Access Compliance Report

Public Rights-of-Way

Intersection ID: 42486	Main Street: ALEXANDER MARTIN_AV	Cross Street: ALMA BLOUNT_BV	Location: NW
ADA ID: 22003D146074	Ramp Type: Perp	Initial Pass/Fail: Fail	Overall Compliance: No
Severity Score: 21.25			
Codes/Mitigation Info/Possible Solution		Field Measurements/Component Compliance

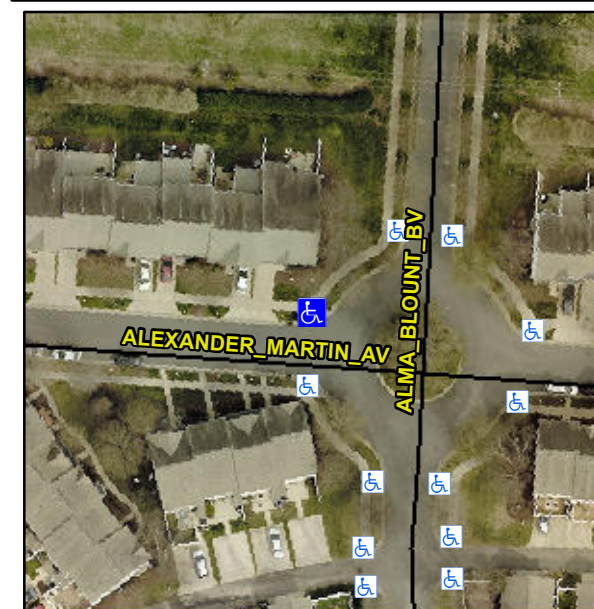
R304.5.1, R304.2.2

Compliance	Description	Data	Compliance	Description	Data
N/A	Ramp Length (in)	63.0	No	Ramp Slope (%)	11.8
No	Ramp Width (in)	43.0	Yes	Ramp XSlope (%)	0.4
N/A	Flare Type LT	N/A	N/A	Flare Type RT	N/A
N/A	Flare Slope LT (%)	N/A	N/A	Flare Slope RT (%)	N/A
N/A	Flare Traversable LT?	N/A	N/A	Flare Traversable RT?	N/A
N/A	Landing Length (in)	N/A	N/A	DWS Provided?	N/A
N/A	Landing Width (in)	N/A	N/A	DWS Contrast?	N/A
N/A	Landing Slope (%)	N/A	N/A	DWS Length (in)	N/A
N/A	Landing X Slope (%)	N/A	N/A	DWS Full Width?	N/A
N/A	Landing Curb? (Y/N)	N/A	N/A	DWS Offset (in)	N/A
N/A	Shared Landing?	N/A			
N/A	Gutter Ponding?	N/A	N/A	Gutter Slope (%)	N/A
N/A	Gutter Lip Ht (in)	N/A	N/A	Gutter X Slope (%)	N/A
N/A	Painted X Walk1?	No	N/A	Painted X Walk2?	N/A
	X Walk 1 Direction	To SW		X Walk 2 Direction	N/A
N/A	X Walk 1 Width (in)	N/A	N/A	X Walk 2 Width (in)	N/A
	X Walk 1 Slope (%)	0.7		X Walk 2 Slope (%)	N/A
	X Walk 1 X Slope (%)	2.6		X Walk 2 X Slope (%)	N/A

Remove & Replace Entire Ramp.
